<b>Title</b>	<b>PLANNING APPLICATION UPDATE REPORT</b>
<b>Ward</b>	Adjacent to Emmer Green
<b>Planning Application Reference:</b>	PL/25/0731 Adjoining Authority Consultation (SODC ref. P25/S1431/O)
<b>Site Address:</b>	Land West of Kidmore End Road Emmer Green Oxfordshire RG4 8SG
<b>Proposed Development</b>	Outline planning application for the development of up to 70 homes (including affordable housing), new vehicular access, associated parking and landscaping (all matters reserved except for access).
<b>Recommendations</b>	As per main report but with this additional comment: 1. SODC should request an updated arboricultural method statement from the Applicant, in respect of the impact of provision of the necessary visibility splay on Highdown Hill Road upon existing trees and hedgerows and consider any impacts as part of their determination of the planning application.

### Proposed cycle link connection onto Highdown Hill Road

Figure 1 – Proposed cycle route connection from the development with Highdown Hill Road (Borough boundary shown as blue line)

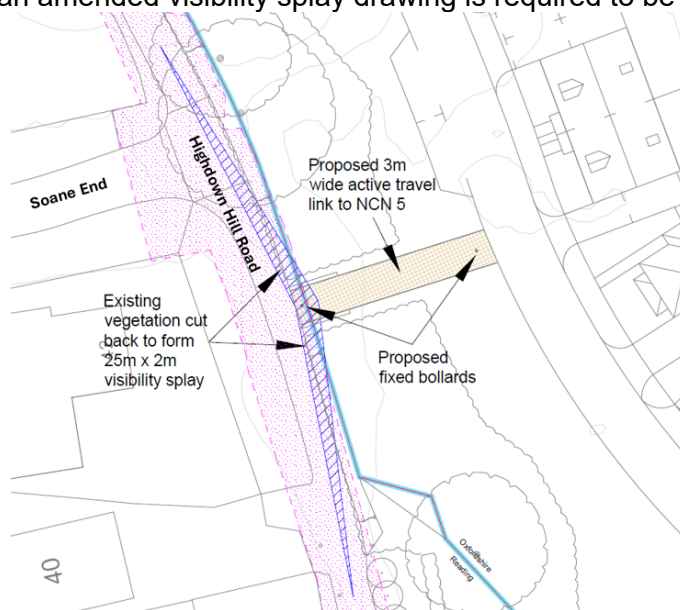
1. Since publication of the main agenda it has been identified that the proposed cycle route connection, which would link the proposed development to Highdown Hill Road (within Reading Borough) and a direct connection of the development to the National Cycle Network (NCN Route 5), would necessitate cutting back of significant vegetation (trees and hedgerows) along Highdown Hill Road in order to provide the necessary visibility splay at the proposed cycle route connection. Figure 1 below shows the proposed visibility splay referred to within the Transport Statement submitted with the application, albeit as set out in the main report the dimensions of the visibility display shown are currently incorrect and an amended visibility splay drawing is required to be provided.

2. The extent of cutting back or vegetation removal to facilitate the necessary visibility splay is not detailed within the arboricultural method statement submitted in support of the application nor other application documents. Therefore, it is not possible to comment with any certainty on the impact upon these trees and hedgerows, some of which appear to be located within Reading and some within South Oxfordshire. The application seeks that matters relating to access are considered in detail at this stage of the application and are not one of the reserved matters and therefore this matter should be resolved prior to determination of the application. It is therefore recommended that RBC comments to SODC should be amended to also advise that SODC should seek clarity, including an updated arboricultural method statement, from the Applicant in respect of the impact of provision of the necessary visibility splay upon these existing trees and hedgerows and consider any impacts as part of their determination of the planning application.
